TOWN OF LOS GATOS COUNCIL AGENDA REPORT

DATE:	December 12, 2024
TO:	Town Council
FROM:	Chris Constantin, Town Manager
SUBJECT:	Consider an Appeal of a Planning Commission Decision to Approve an Architecture and Site Application for Construction of a Single-Family Residence and Site Improvements Requiring a Grading Permit on Vacant Property Zoned R-1:8. Located at 15411 National Avenue. APN 424-12- 140. Architecture and Site Application S-23-033. Categorically Exempt Pursuant to CEQA Guidelines Section 15303: New Construction. Property Owners: Vyankatesh and Ramya Muddada. Applicant: Jose Rama. Appellant: Hellen Martinez. Project Planner: Erin Walters.
	reneri wardinez. i roject i armer, Erni Walters.

PAGE 2 OF 10 SUBJECT: 15411 National Avenue/S-23-033 DATE: December 17, 2024

DATE: November 8, 2024
TO: Planning Commission
FROM: Joel Paulson, Community Development Director
SUBJECT: Requesting Approval for Construction of a Single-Family Residence and Site Improvements Requiring a Grading Permit on a Vacant Property Zoned R-1:8.
Located at 15411 National Avenue. APN 424-12-140. Architecture and Site Application S-23-033. Categorically Exempt Pursuant to CEQA Guidelines Section 153

Figure 7 – Windows in the structure raising privacy concerns

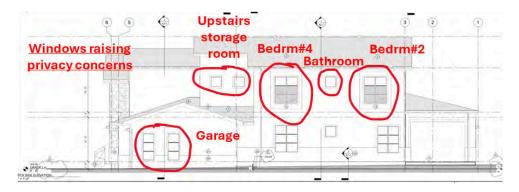
2) Privacy concerns: The proposed three level structure raises serious various privacy concerns for us. Our houses face back. Since it is positioned in the center of the city block and given its very large size, it has numerous windows on its second and first floors facing our backyard, with direct visibility into three of our bedrooms and other outdoor and lower-level indoor living areas (family room). Additionally, we are concerned that the privacy concerns will worsen in the future due to the owners' stated intent of converting their flag lot into a multi-dwelling complex by subsequently adding (at least) two ADUs. The numerous windows facing upper- and lower-level indoor living spaces in our property in the proposed design correspond to two upstairs bedrooms, one upstairs bathroom, an upstairs storage room, and the downstairs garage, as shown in Figure 7.

The most optimum solution to address our privacy concerns would be to move Bedrooms #2 and #4 to the downstairs space directly below, currently shown as a "guest room" and as a very large "garage storage room." This would also decrease the size of the upstairs level and partially address our strong concerns about the size and massing of the structure described in section #1 above. Alternatively, these windows could either be eliminated or re-positioned. The details of our privacy concerns are as follows:

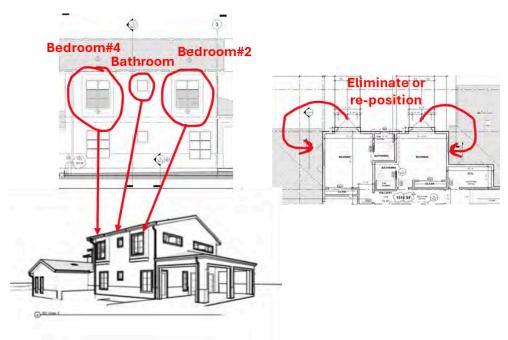
A. The windows in Bedroom #2, Bedroom #4, and the upstairs bathroom currently facing NNW have a direct line of sight into our master bedroom & bathroom upstairs, our bedroom upstairs, our bedroom downstairs, and our kitchen/family room.

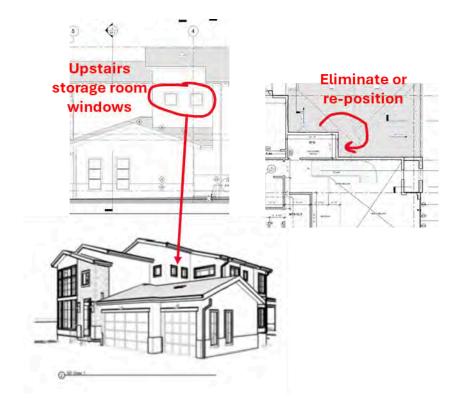
B. The two windows facing NNW in the upstairs Storage Room have a direct line of sight into our master bedroom & bathroom upstairs, our bedroom upstairs, our bedroom downstairs, and our kitchen/family room.

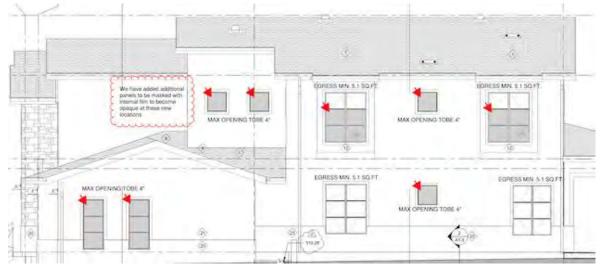
e. We are going to put permeant obscure glass to cover the line of sight on both the egress windows and to address the planning commission councils' conditions of approval we have decided to obscure additional windows.

Our garage windows, storage windows and bathroom windows will have 4inch opening, please note none of these windows are in the line of site and they are non-offending. Please see the picture below.

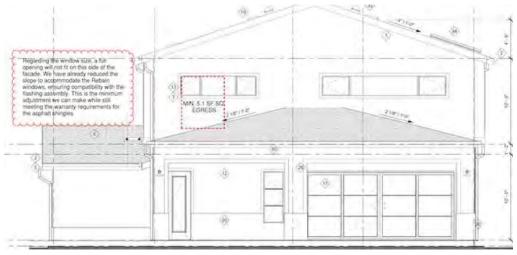
The second egress window has multiple issues due to which this cannot be moved.

- a. We had assured 113 Leila Ct neighbor that there would be no egress window on the back side of the property facing their property, this discussion is in the staff report as part of neighborhood reach out.
- b. Our current patio roof design doesn't allow for an egress window in the back, please see the picture below.
